APPENDIX F
EXPERT PANEL'S BMP SITE RANKING ANALYSIS MEMORANDUM
2014/2015 RAINY SEASON

**SANTA SUSANA SITE WATERSHED 008 AND
009 BMP SUBAREA RANKING ANALYSIS**

Santa Susana Field Laboratory

Surface Water Expert Panel

Figure ES-1: B1 Area

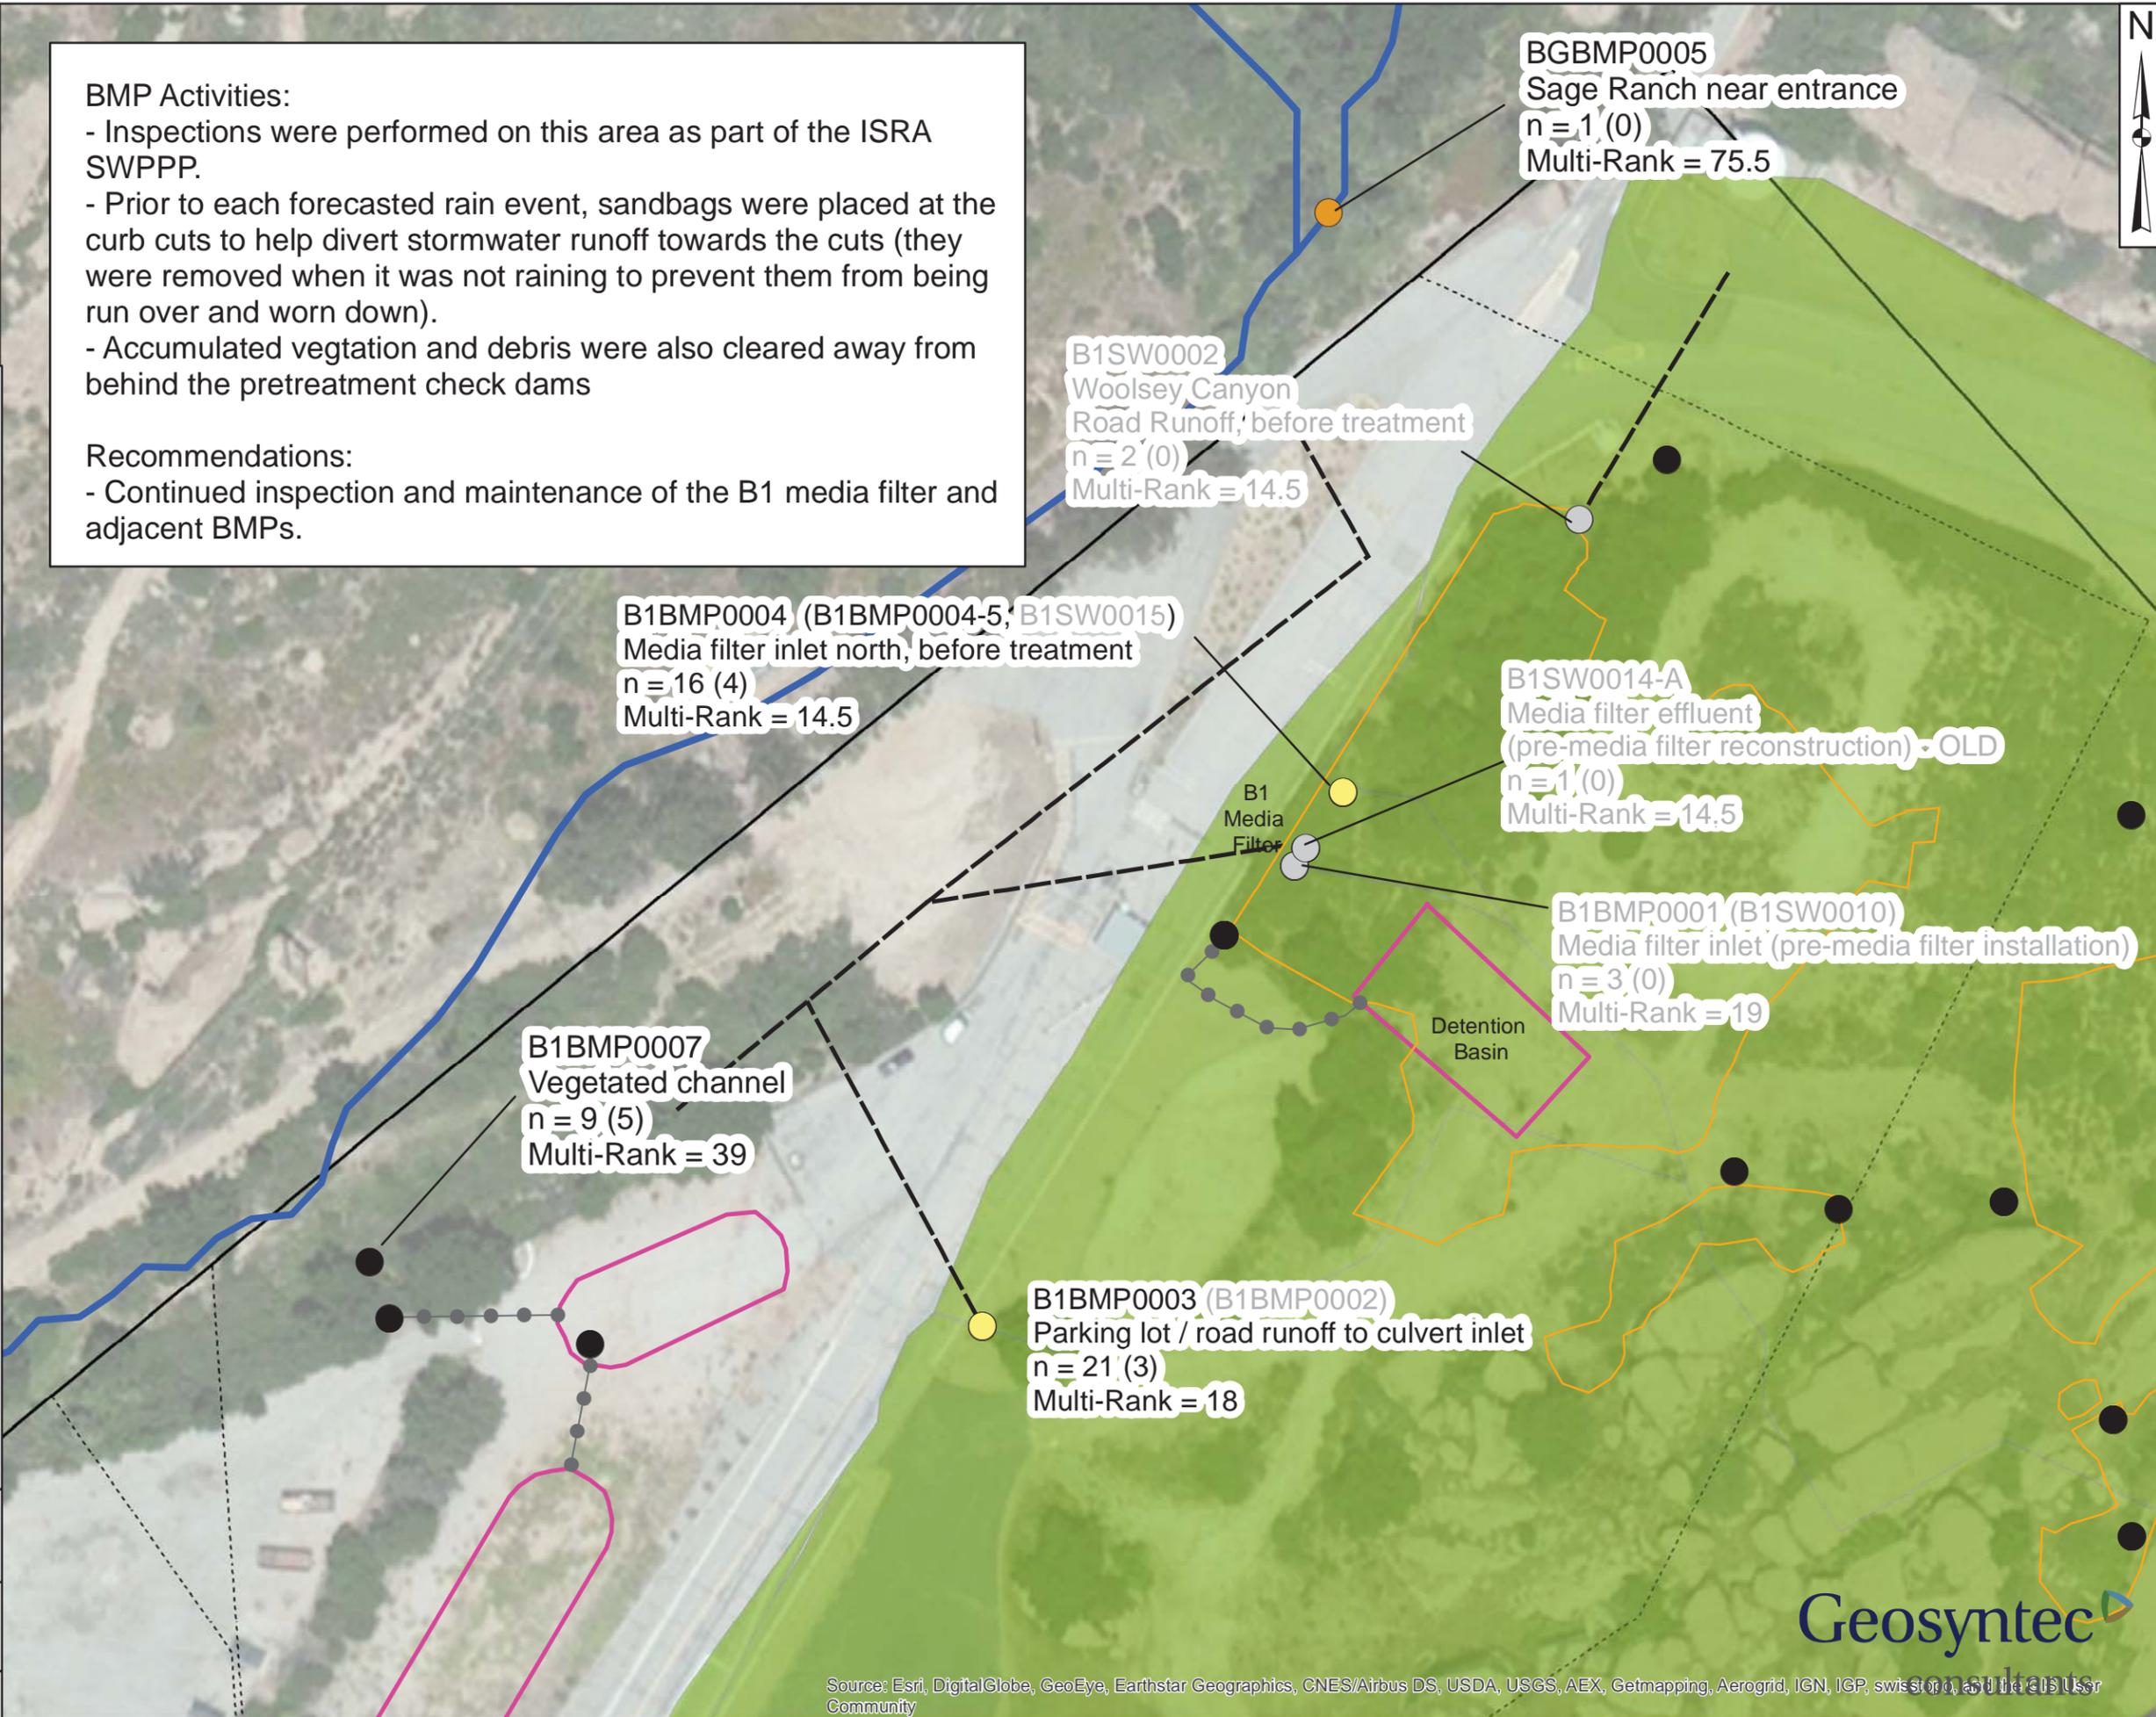
- Inspections were performed on this area as part of the ISRA SWPPP.
- Prior to each forecasted rain event, sandbags were placed at the curb cuts to help divert stormwater runoff towards the cuts (they were removed when it was not raining to prevent them from being run over and worn down).
- Accumulated vegetation and debris were also cleared away from behind the pretreatment check dams

- Continued inspection and maintenance of the B1 media filter and adjacent BMPs.

Figure ES-2: Lower Lot
 Santa Susana Field Laboratory
 Ventura County, CA
 August 2015

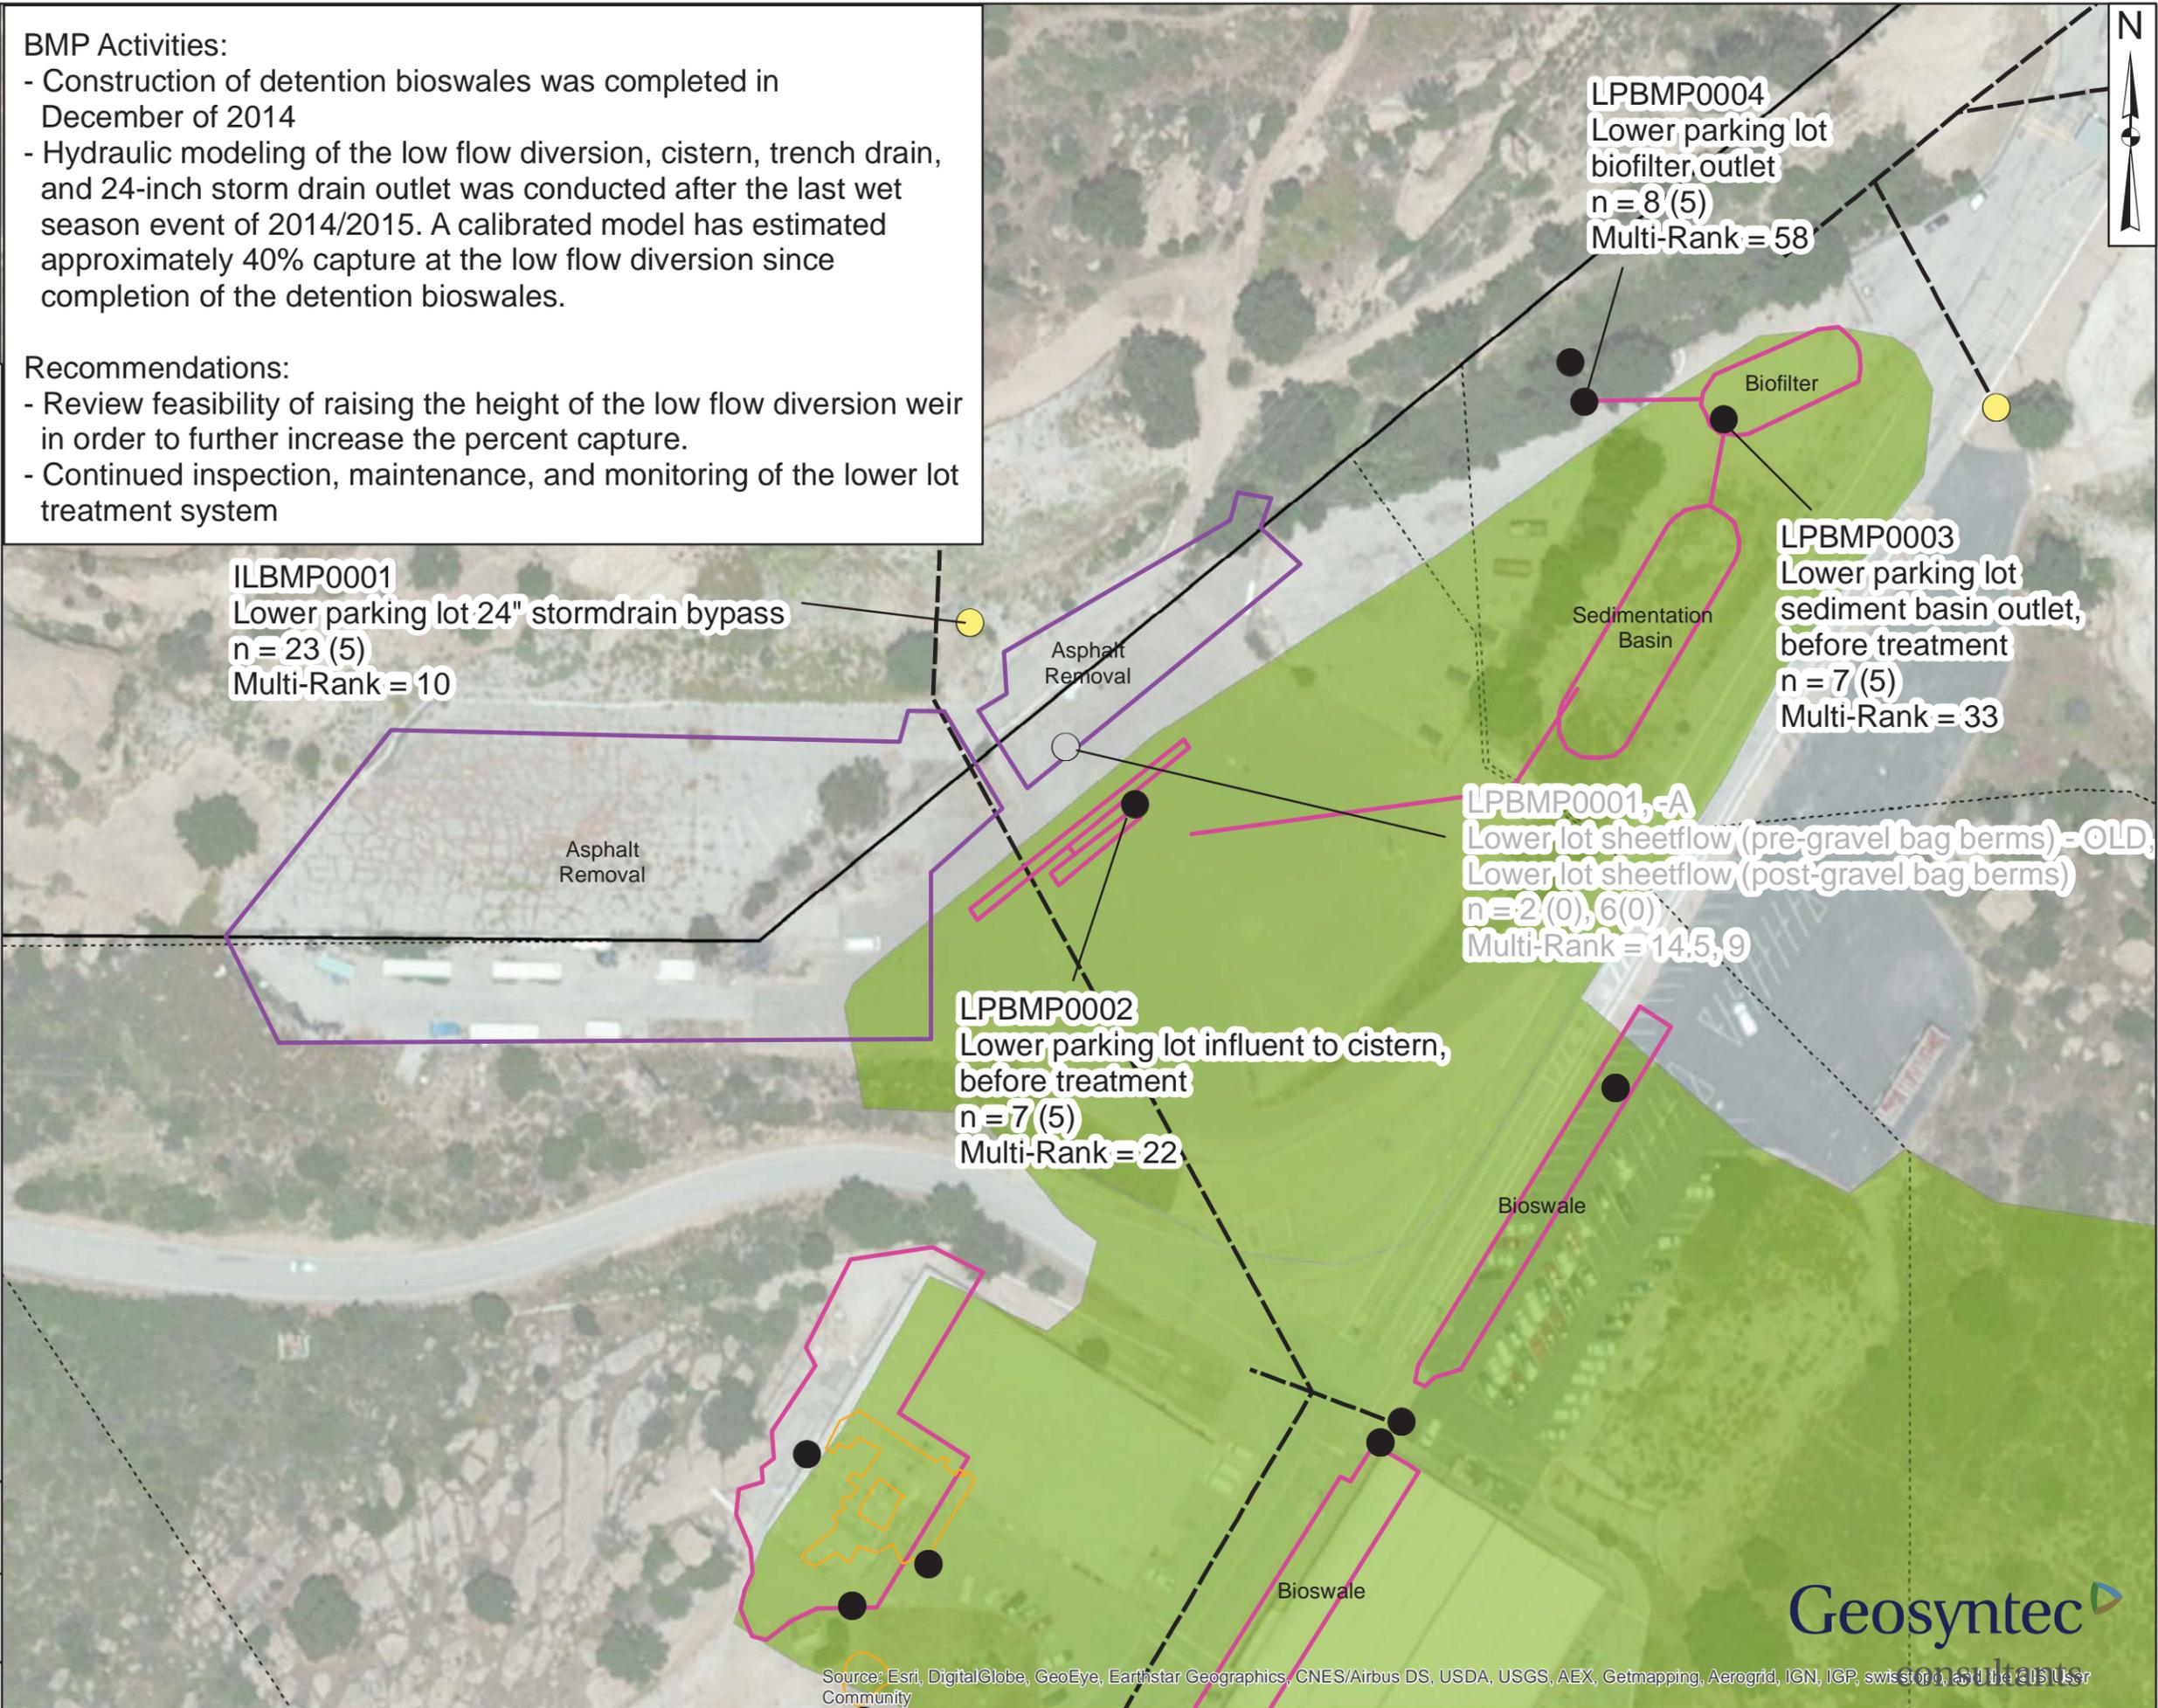
- Construction of detention bioswales was completed in December of 2014
- Hydraulic modeling of the low flow diversion, cistern, trench drain, and 24-inch storm drain outlet was conducted after the last wet season event of 2014/2015. A calibrated model has estimated approximately 40% capture at the low flow diversion since completion of the detention bioswales.

- Review feasibility of raising the height of the low flow diversion weir in order to further increase the percent capture.
- Continued inspection, maintenance, and monitoring of the lower lot treatment system
